# REVIEW COMMENTS

FILE #137-93

TITLE HEADING: Site Plan Review - Antler Art

LOCATION: 2517 Weslo Court

1 SITE PLAN SP1 SCALE: 1" = 10'-0"

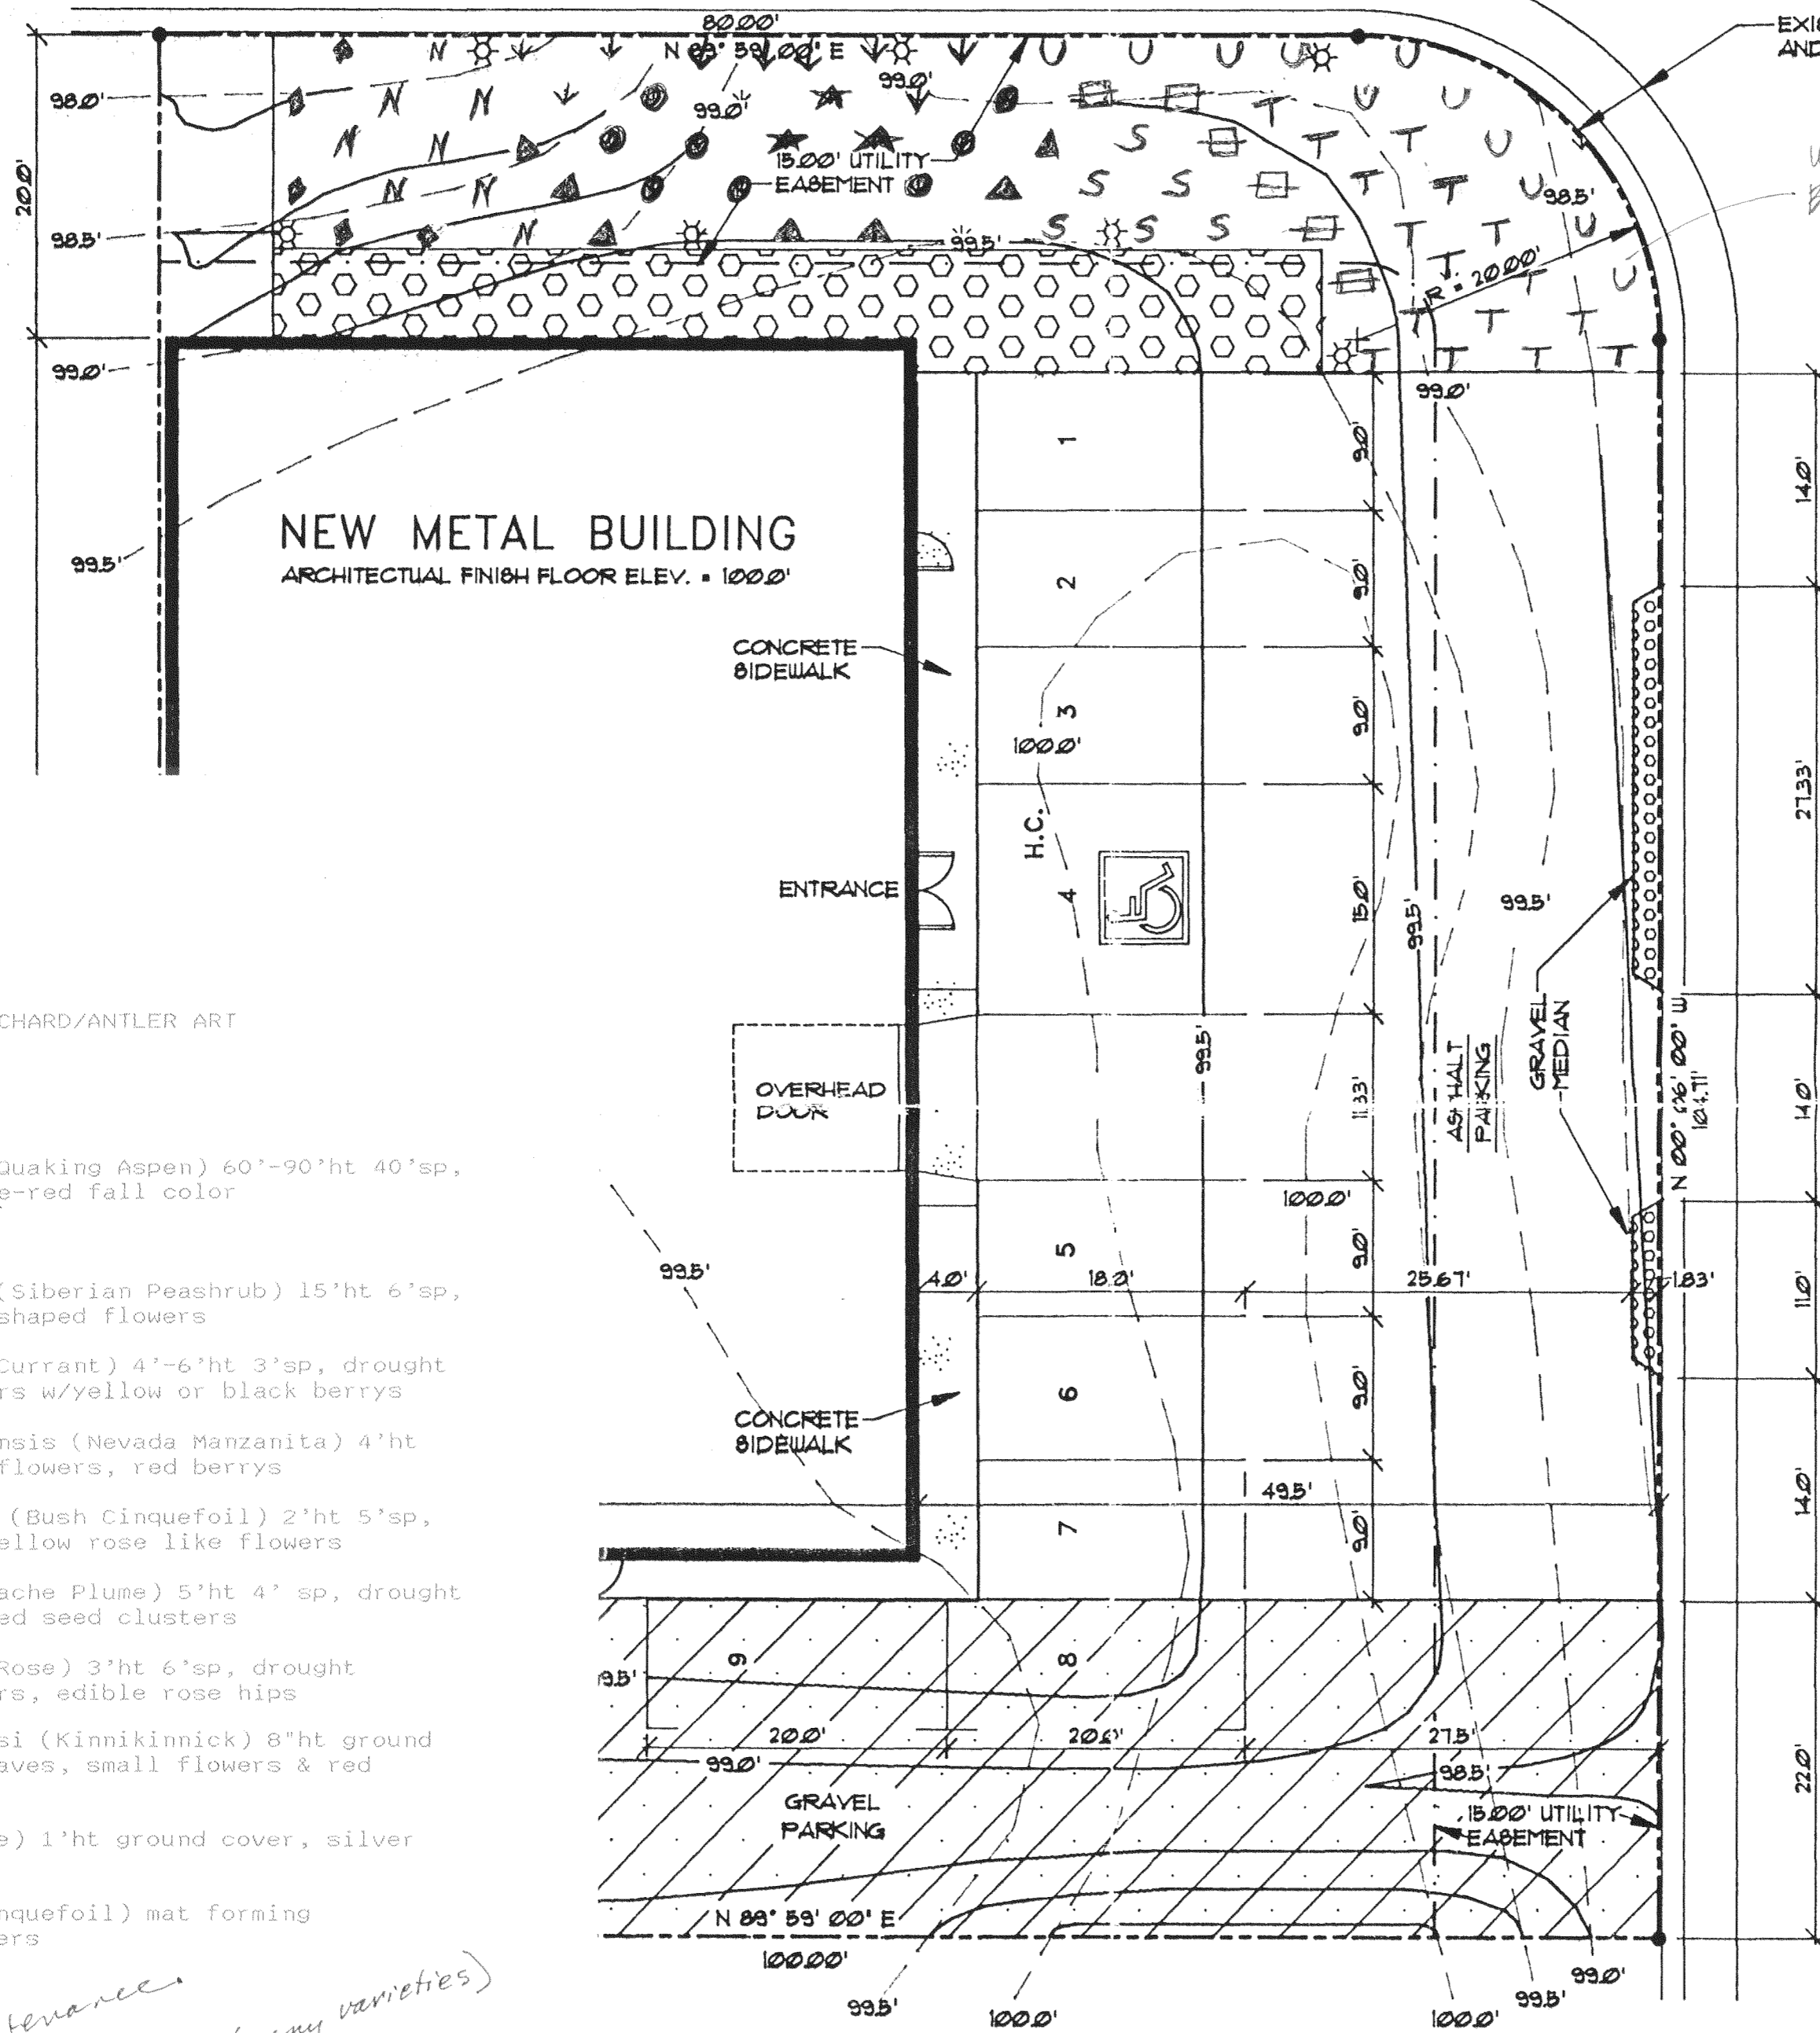
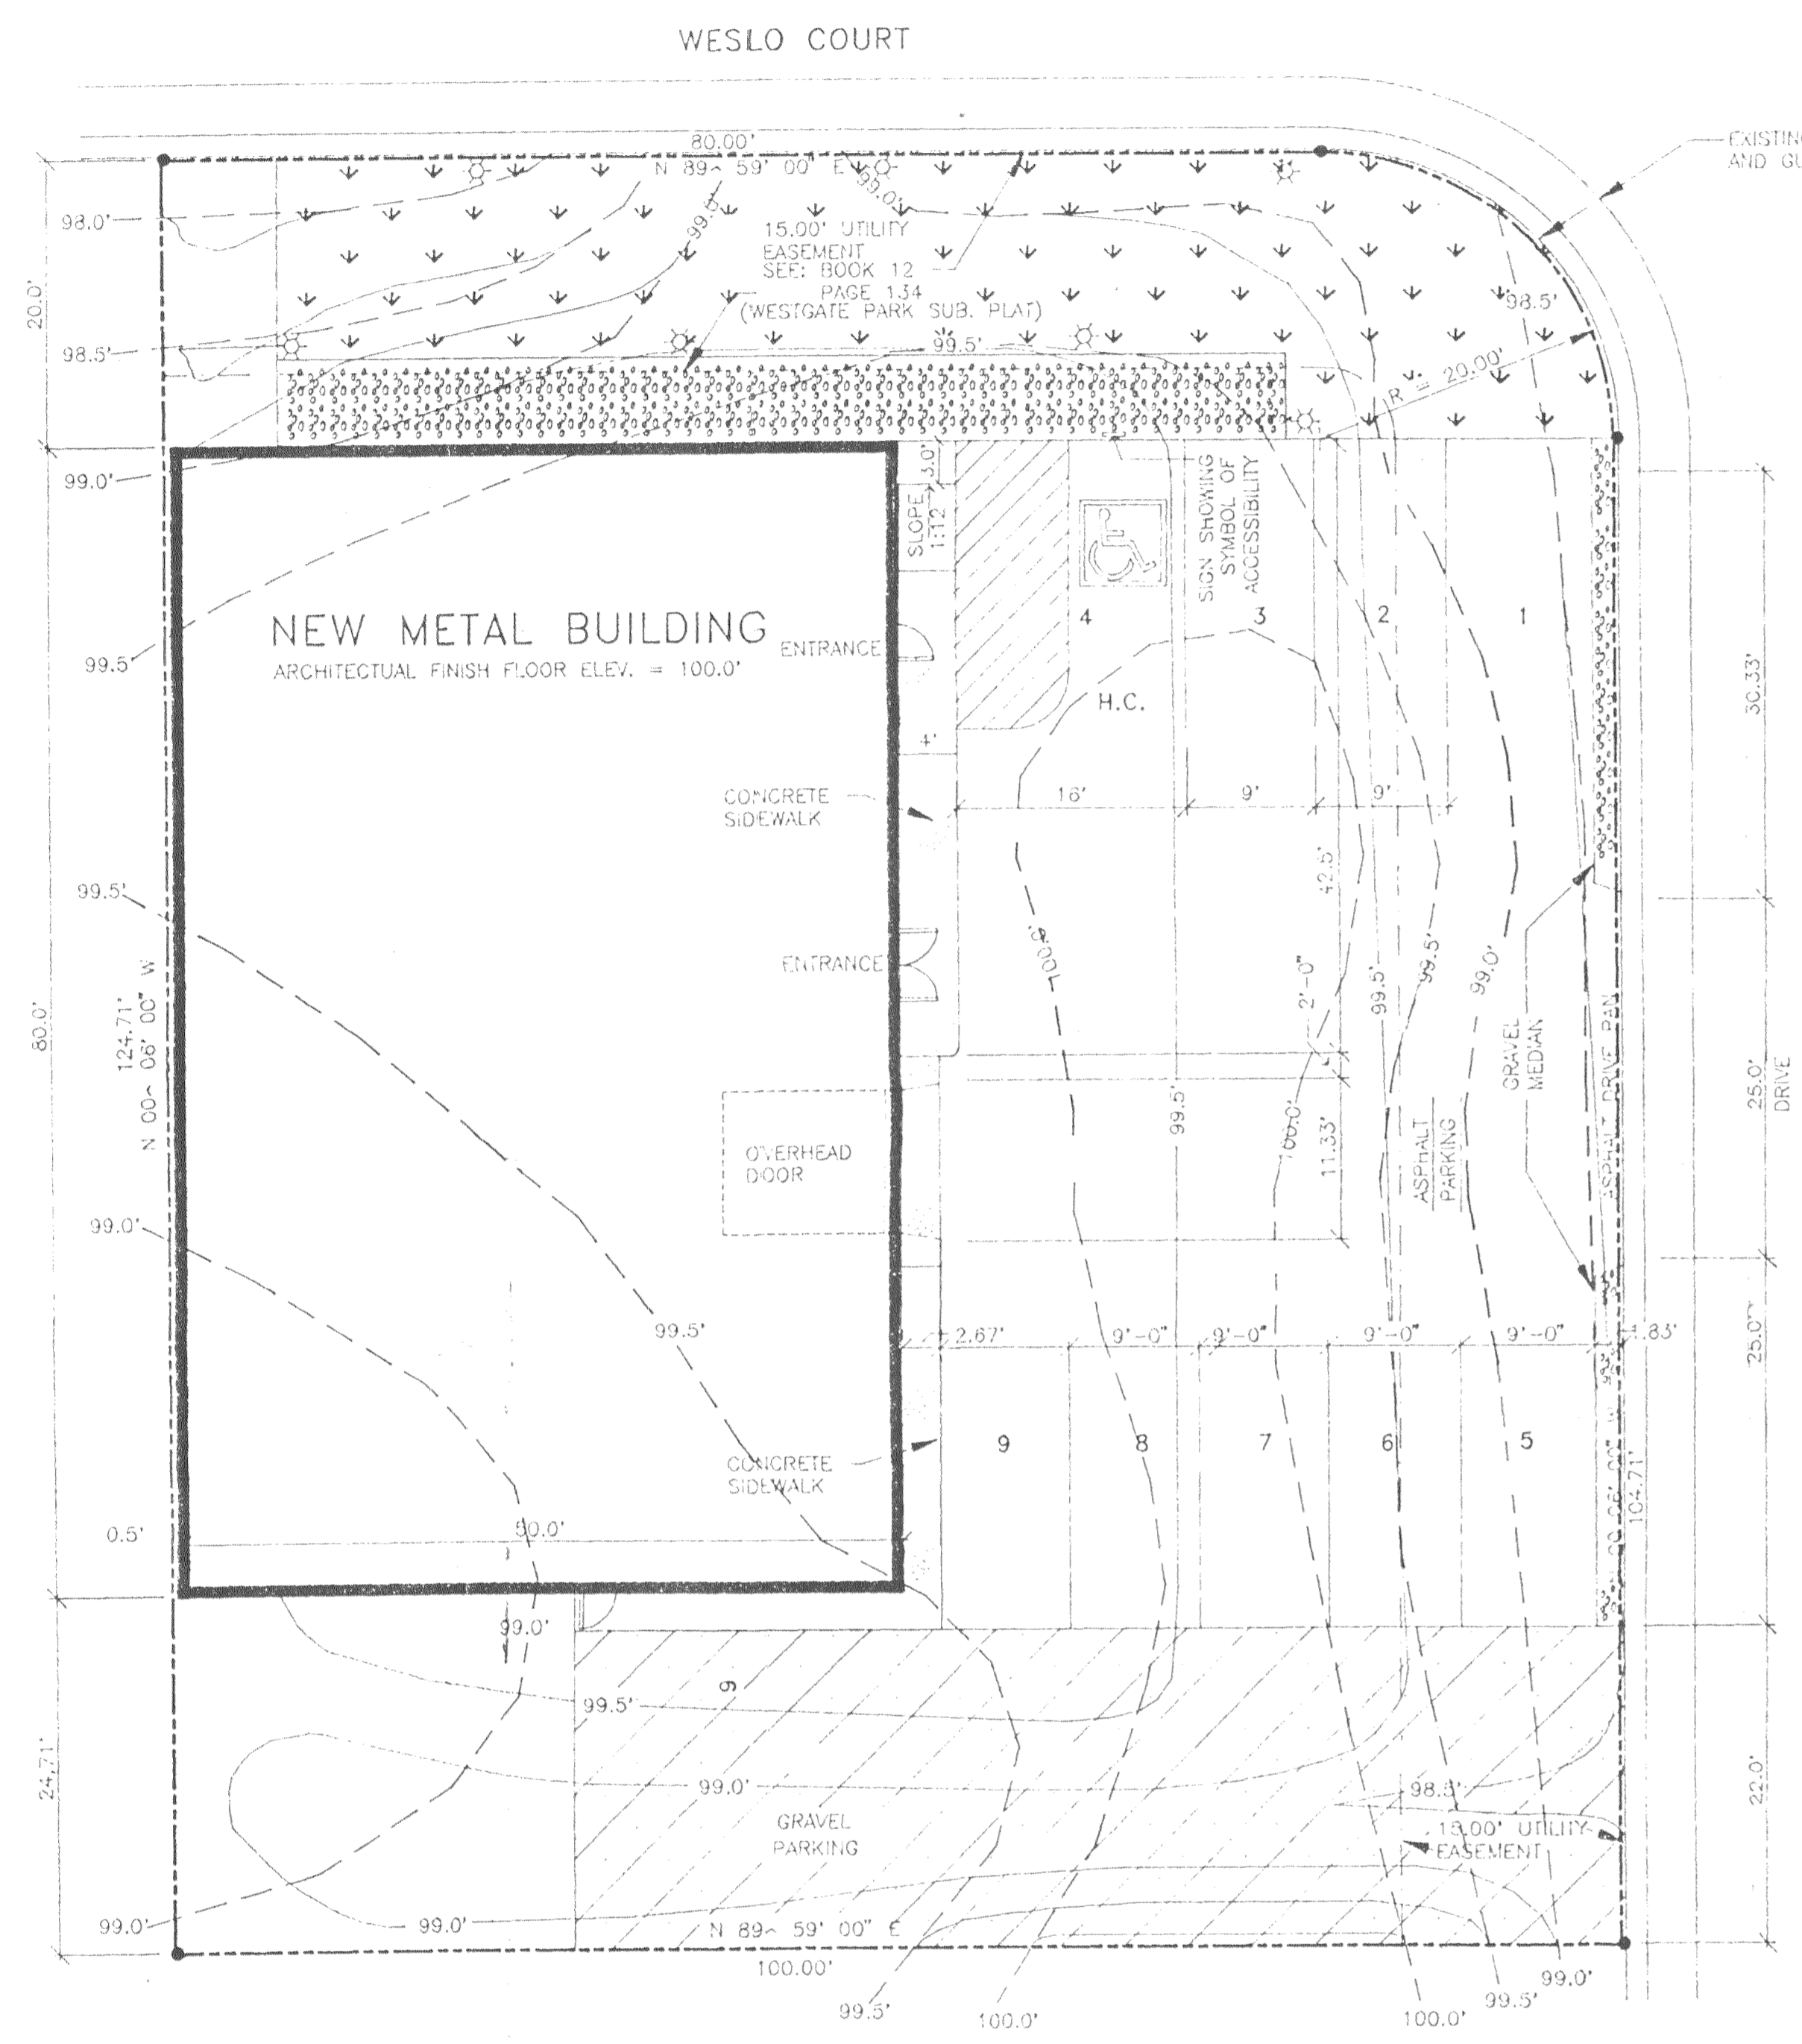
Question whether these will survive in an industrial area without intensive maintenance - Alternative ground cover: Sedum (many varieties) Artemisia schmidtiana Penstemon Ask Nursery for drought tolerant, sunny groundcover.

coverage may not be adequate

Approved Landscaping plan  
KP  
12/28/93
